Revision C2 Planning Update Notes:

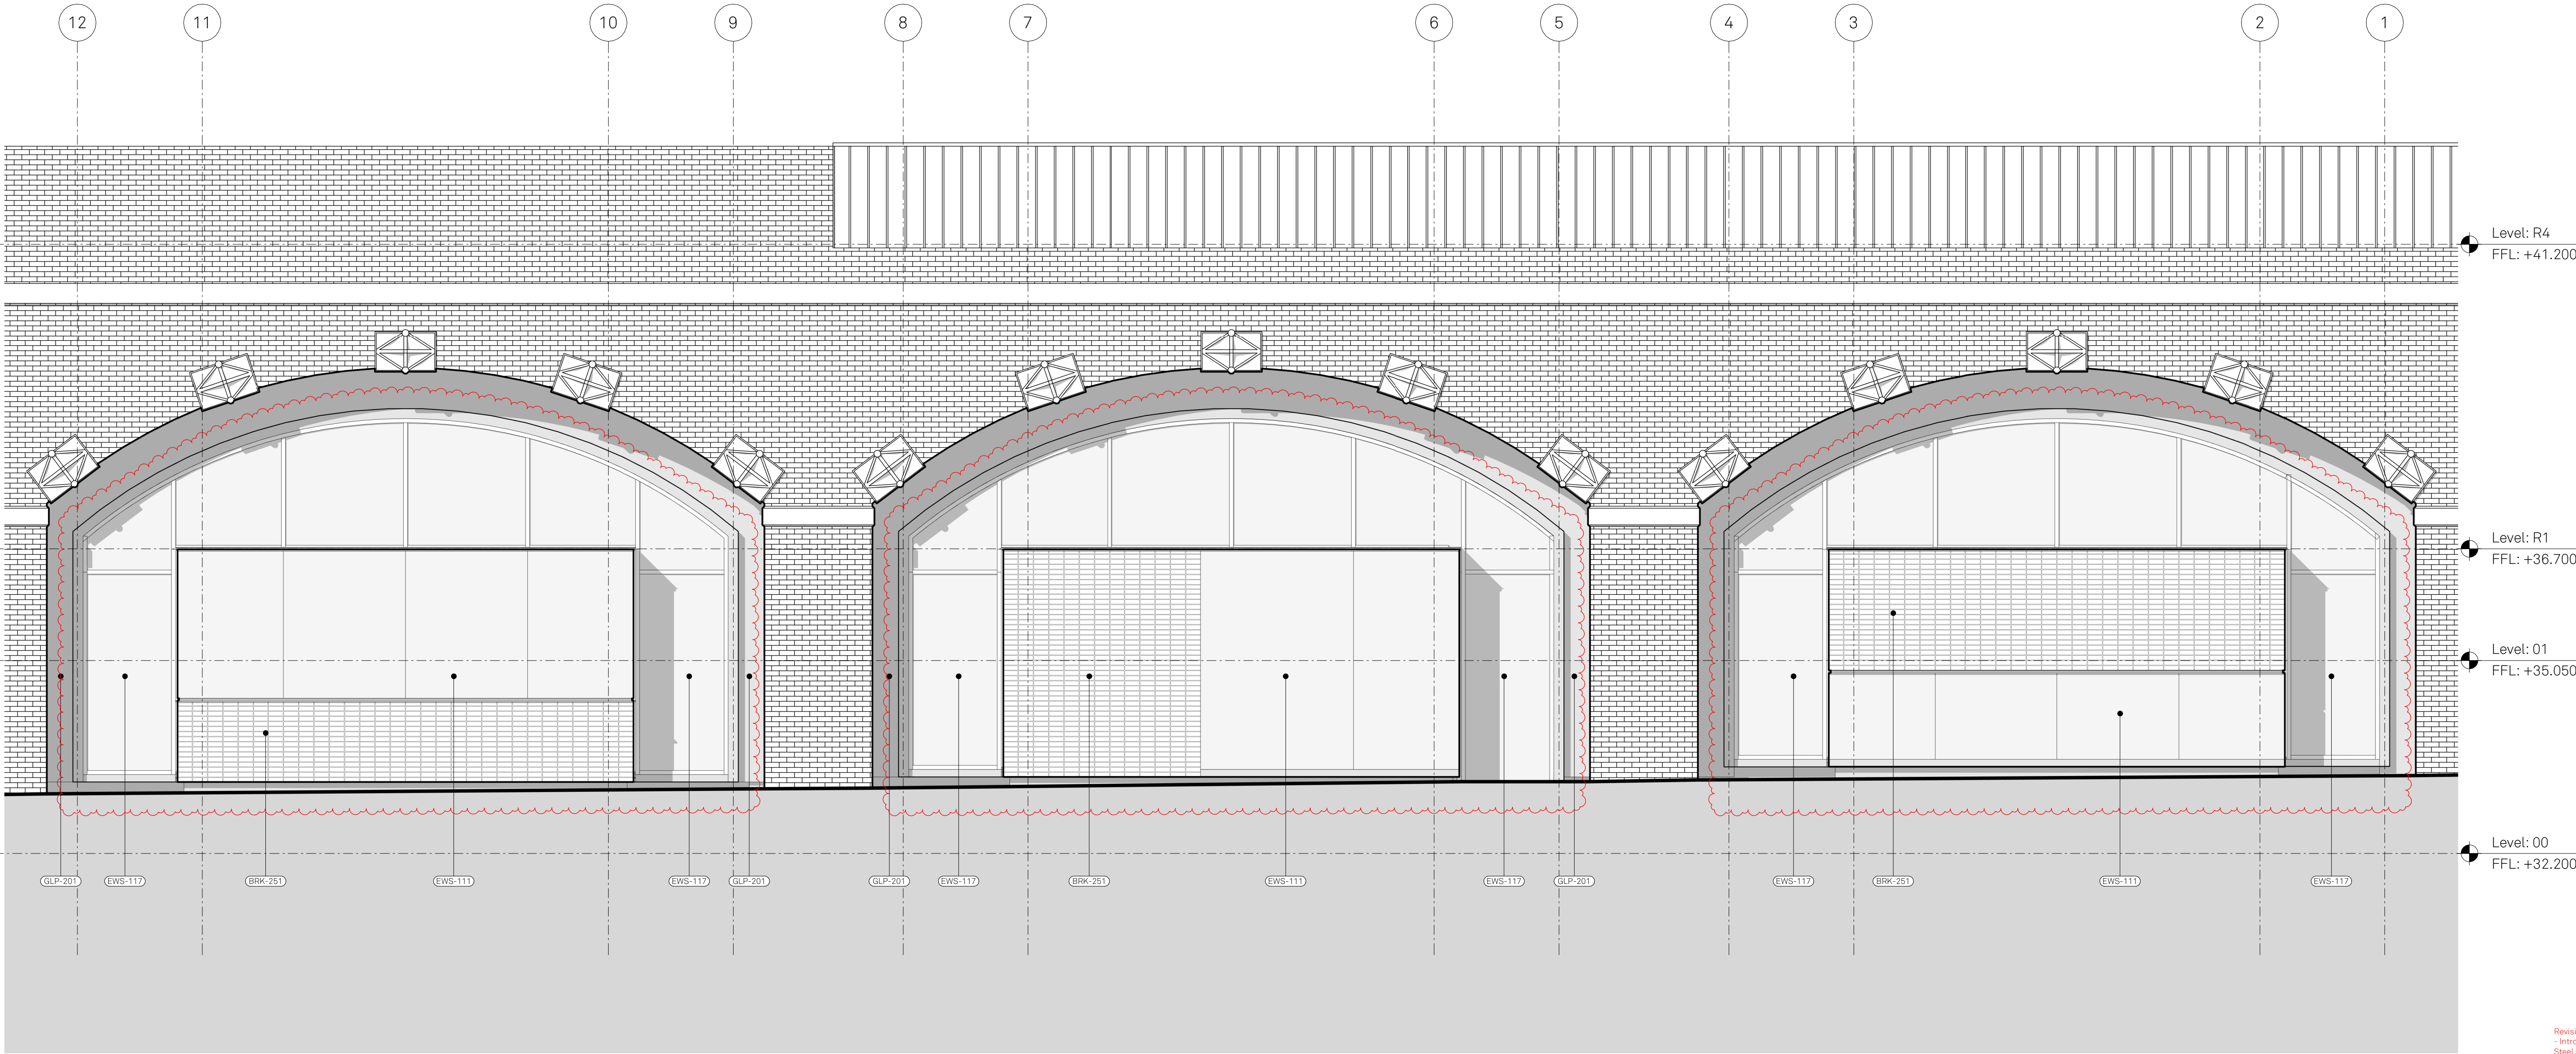
- Introduction of the network rail 350mm service zone.
- Steel structure reduces in size, reducing the width of pods by a brick on either side is required. Centre line of the arches maintained.
- Introduction of Capped CW System to the main arches.
- External levels adjusted following updated survey information. Bottom of pods updated to suit, top of pod levels maintained.
